## **ADDENDUM NO. TWO**

**REBID – USC Upstate Baseball Field  
Drainage System Improvements  
State Project No. H34-I376  
WKD Project No. 20170043.00.CA**

**May 3, 2017**

DRAWING TITLE: SITE IMPROVEMENT PLAN

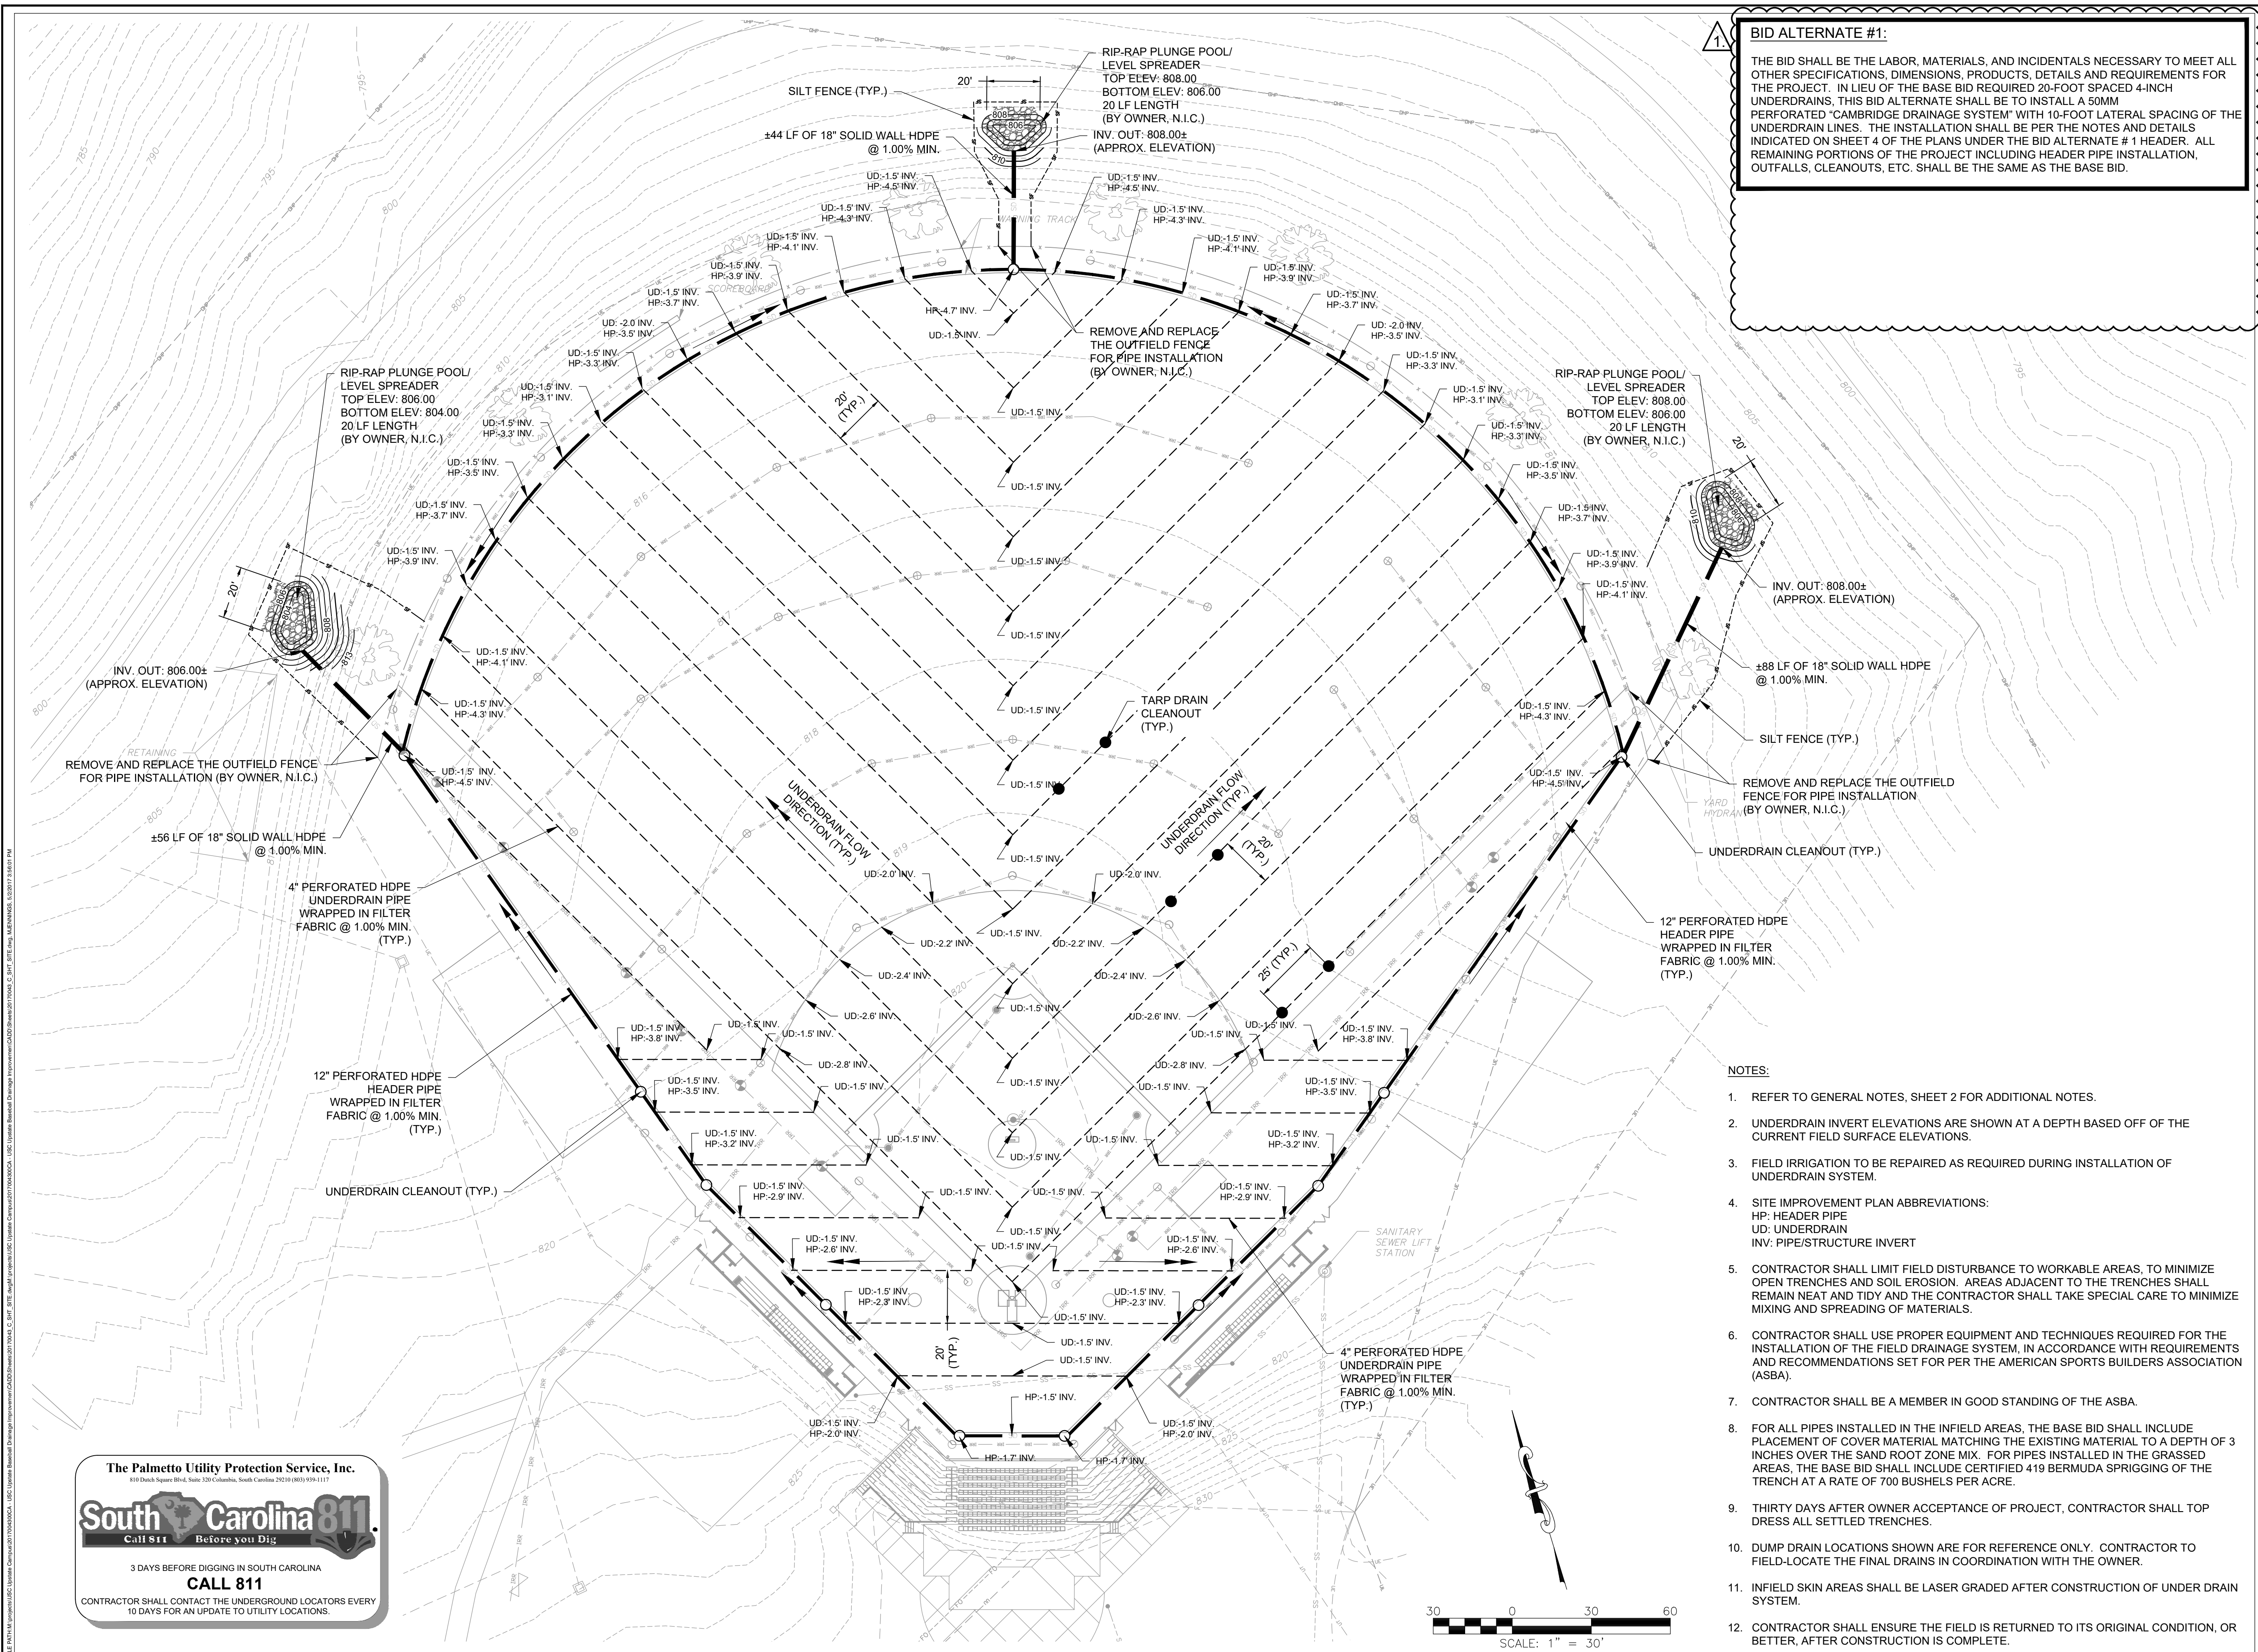
1. The owner has chosen to revise Bid Alternate 1, to allow the Cambridge Drainage System. The details and requirements of the system are found on the revised plans sheets, 3 and 4. In lieu of the Base Bid required 20-foot spaced 4-inch underdrains, this bid alternate shall be to install a 50mm perforated “Cambridge Drainage System” with 10-foot lateral spacing of the underdrain lines. The installation shall be per the notes and details indicated on sheets 3 and 4 of the revised plans under the Bid Alternate # 1 designation. All remaining portions of the project including header pipe installation, outfalls, cleanouts, etc. shall be the same as the Base Bid.
2. The attached revised SE-330 – Lump Sum Bid Form shall be used by all contractors bidding on the project. Each bidder must include a Base Bid.

1. Replace plan sheets 3 and 4 in their entirety with the attached revised plan sheets.

**BID ALTERNATE #1:**

THE BID SHALL BE THE LABOR, MATERIALS, AND INCIDENTALS NECESSARY TO MEET ALL OTHER SPECIFICATIONS, DIMENSIONS, PRODUCTS, DETAILS AND REQUIREMENTS FOR THE PROJECT. IN LIEU OF THE BASE BID REQUIRED 20-FOOT SPACED 4-INCH UNDERDRAINS, THIS BID ALTERNATE SHALL BE TO INSTALL A 50MM PERFORATED "CAMBRIDGE DRAINAGE SYSTEM" WITH 10-FOOT LATERAL SPACING OF THE UNDERDRAIN LINES. THE INSTALLATION SHALL BE PER THE NOTES AND DETAILS INDICATED ON SHEET 4 OF THE PLANS UNDER THE BID ALTERNATE # 1 HEADER. ALL REMAINING PORTIONS OF THE PROJECT INCLUDING HEADER PIPE INSTALLATION, OUTFALLS, CLEANOUTS, ETC. SHALL BE THE SAME AS THE BASE BID.
